CLARK COUNTY, NEVADA
BID NO. 603466-14
VALLEY VIEW BOULEVARD – CACTUS AVENUE TO SILVERADO RANCH
BOULEVARD

ADDENDUM NO. 1

VALLEY VIEW BLVD. - CACTUS AVENUE TO SILVERADO RANCH BLVD.
PAVEMENT MARKING
 STA 10+00 - STA 31+00
 CLARK COUNTY, NEVADA, DEPARTMENT OF PUBLIC WORKS

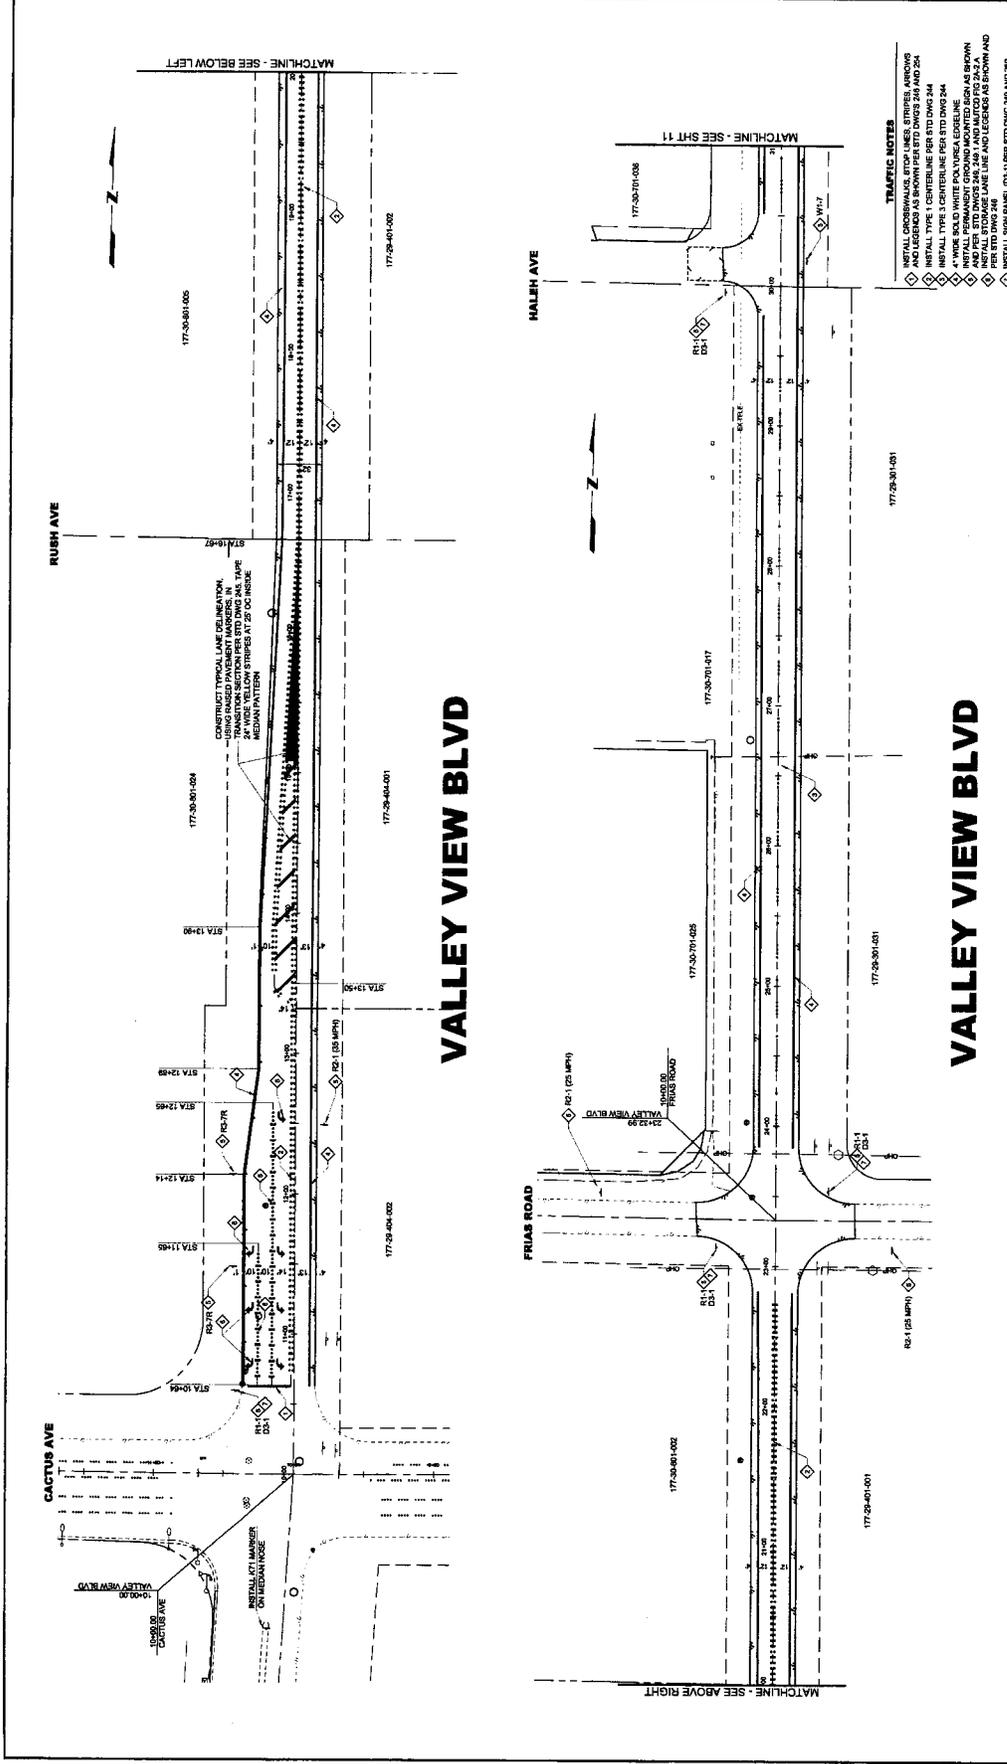
5. The following sheets are being reissued with this addendum.
 - a. Sheet 4 - Typical Sections revised
 - b. Sheet 10 - Striping Revised at Cactus Ave Intersection and Signage added
 - c. Sheet 11 - Signage added
 - d. Sheet 12 - Signage added
6. The following sheets are NOT being reissued with this addendum. The Contractor shall make the following changes, which will be reflected in the "Issued for Construction" plans.
 - a. Sheet 2 – Summary of Approximate Quantities changed to coincide with Bid Form
 - b. Sheet 5 – Corrected dimension at Sta. 13+50.00 from 16.00' RT to 15.00' RT
